## Commission of Architectural Review

5. COA-186201-2026	Final Review Meeting Date: 6/23/2026
Applicant/Petitioner	Jeff Shryer
Project Description	Construct new brick privacy wall
Project Location	
Address: 4101 Hermitage Road	
Historic District: Hermitage Road	
<p><b>High-Level Details:</b></p> <p>The applicant requests approval to construct a new brick wall around the rear and side yard of an extant building, on a corner lot.</p> <p>The wall will extend 103 feet across the rear and 126 feet along the side yard adjacent to Pope Avenue.</p> <p>The Brick wall will be six feet tall with 7 ½ foot piers. Panels between piers will be 10ft. apart.</p> <p>Currently in this location, there is a six-foot wood fence. .</p>	
Staff Recommendation	Approval, with Conditions
Staff Contact	Alex Dandridge, Alex.Dandridge@RVA.gov, (804)646-6569
Previous Reviews	Previously the commission reviewed and approved the construction of a rear addition and other exterior alterations at the property IN August 2025.

Figure 8. Recommended end pier to preserve views of side yard and side elevation of building. Recommended to remove last four panels of brick wall.

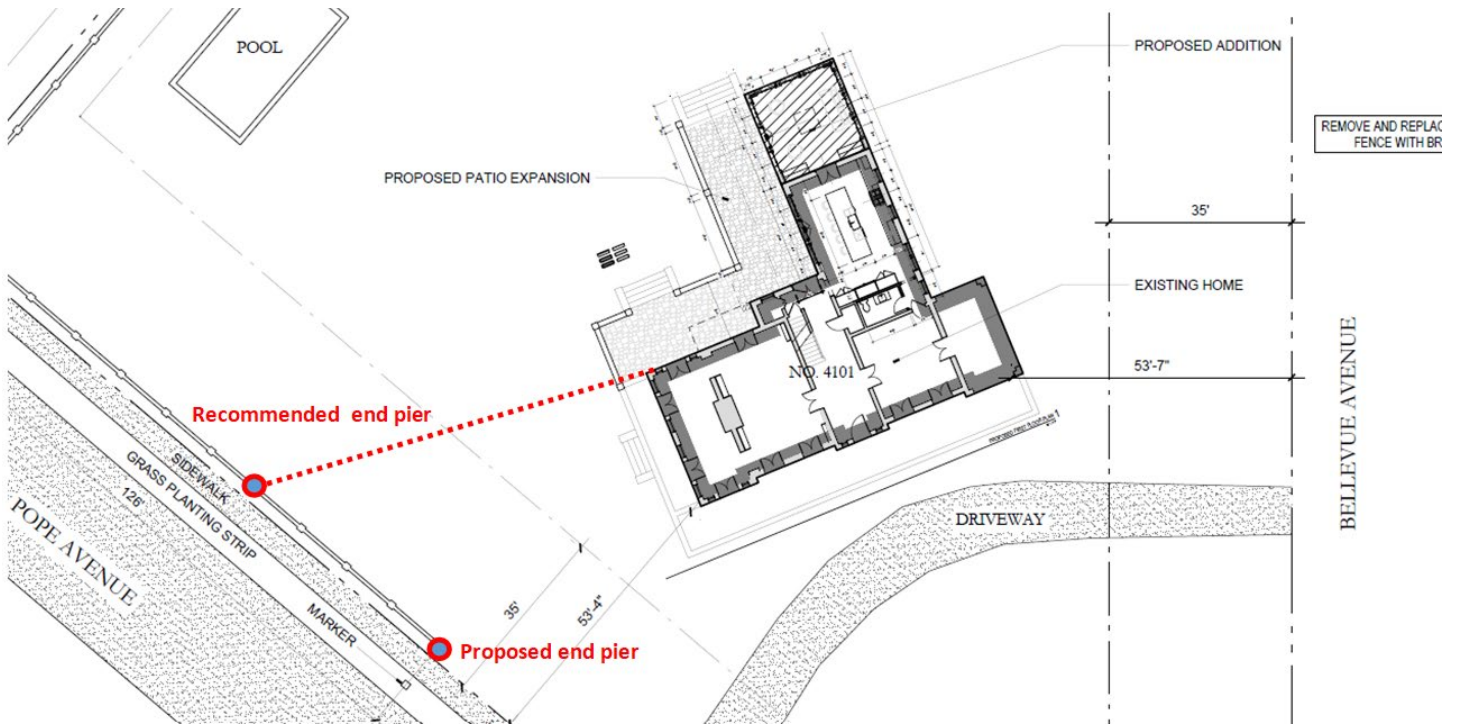
Staff Recommendations	<p>Staff recommends that:</p> <ul style="list-style-type: none"> <li>• The wall be reduced in length on the Pope Avenue side to align with the rear face of the building, removing approximately the last four wall panels (see figure 8),</li> <li>• The wall be reduced in height so that the height of the panels and piers are no taller than the 6 foot height of the extant rear privacy fence. Final design and dimension submitted for staff review and approval.</li> <li>• Brick piers be made in design similar to those found in the historic district in both color and width.</li> <li>• applicant plant an evergreen hedge along the street facing</li> </ul>
